for Lloyd's

NOTES OF INTERVIEW WITH THE REPRESENTATIVES OF LLOYDS AND
JOHN BROWN & COMPANY IN LONDON.

ANCHORS & CHAINS.-

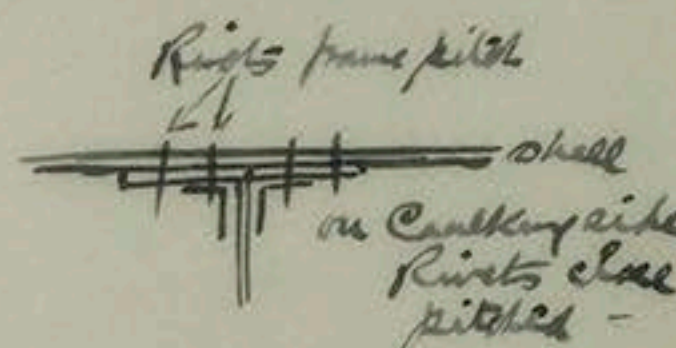
Two bower anchors each of 200 cwt. and one of 155 cwt. to be supplied. The chains to be $3\frac{3}{4}$ diameter by 330 fathoms long. Size of stream chains to be submitted. The Makers names of the Anchors and Chains to be submitted to the Cunard Co.

FRAME FEET.-

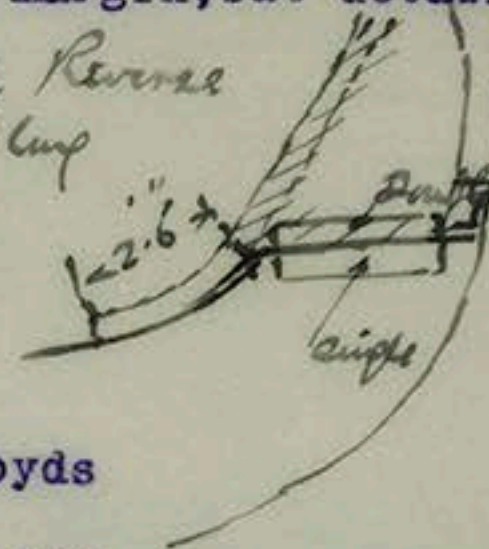
To be connected to tank top as per margin, but detail sketch to be submitted to Lloyds:- *either the Reverse bar, carried down 2-6 or a back bar 5 1/2 long 2-6 of which is to be carried down*
The SHELL within the double bottom to be painted.
